Model: KP-41T15, KP-41T25, KP-41T35, KP-46C36
 KP-46S15, KP-46S17, KP-46S25, KP-46V25
 KP-46V35, KP-48S35, KP-48V45, KP-53S15
 KP-53S17, KP-53S25, KP-53S35, KP-53V25
 KP-53V35, KP-53V45, KP-53XBR45
 KP-53XBR4CT, KP-61S35, KP-61V25
 KP-61V35, KP-61V45, KP-61XBR48

No. 513R1

Subject: CRT Replacement

Date: August 21, 2001

Fig 1

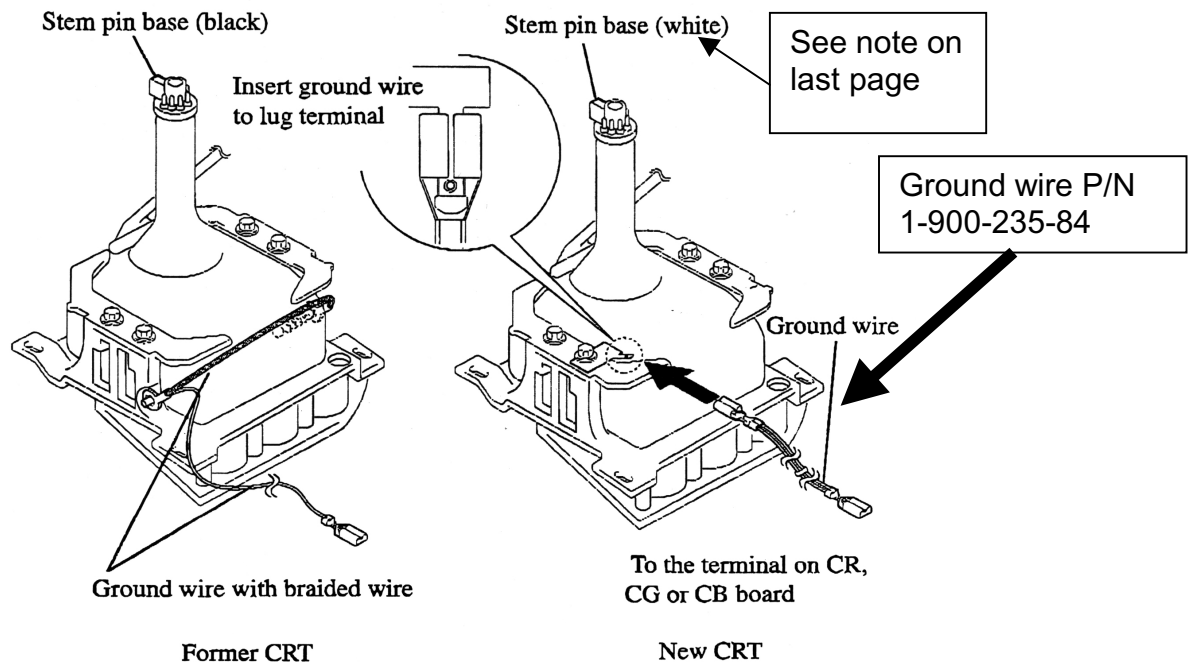
Ground of replacement CRT may be different than the original. Heater resistor value change may be required.

1. When replacing the CRT the original may have used a braided wire across the CRT to ground the CRT and CRT Board. The replacement CRT uses a grounding wire that connects to a ground lug. This grounding lug wire should be packed in the replacement CRT box. See picture below.

In order to determine if the CRT heater resistor is the older value or not, check the color of the CRT plastic pin base stem. (See Fig 1)

Black stem indicates an older CRT and the value of the heater resistor was not changed.

White stem indicates a newer CRT and the value of the heater resistor may require a different value.

1. After replacing the defective CRT, check the color of the CRT plastic pin base stem of all three CRTs. (See Fig 1)
2. The value of the heater resistor, on the E or G Board depending on the model, will be determined by how many of the CRTs have a white stem base. Refer to the chart below.
3. Check the heater resistor value in the set and confirm if it is the correct value as per the chart below. If not please replace the resistor with the correct value.
